PREPARED FOR THE PLAN COMMISSION

**Project Address:** 2501-2525 University Avenue (District 5 – Ald. Bidar-Sielaff)

**Application Type:** Demolition Permit and Conditional Use

**Legistar File ID #** [36811](#)

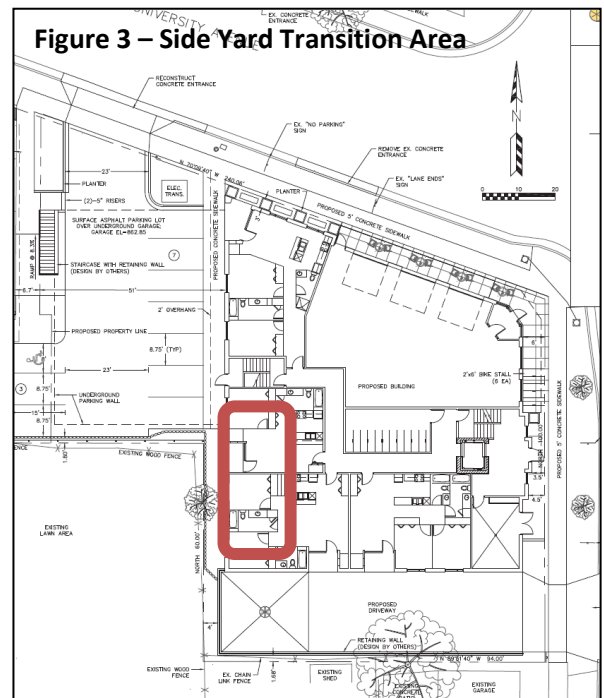
The request to exceed the side/rear yard height transition should also be carefully considered. The area in question is identified in Figure 3. Without conditional use approval, the third floor of the building in this location would need to be "stepped back" at a 45-degree angle above the second floor, as shown by the below zoning code graphic:

In pre-application discussions with the project architect, meeting this standard would result in the reconfiguration of third floor units and the loss of units/bedrooms, which was a significant concern for the development team.

The single-family home at 2510 Kendall Avenue abuts this side lot line. From a grading perspective, that property generally sits between 1-4 feet higher than the proposed subject site, in this area. At the time of report writing, staff has not received any correspondence from that property owner, or other property owners regarding concerns on the proposed setback and stepback.
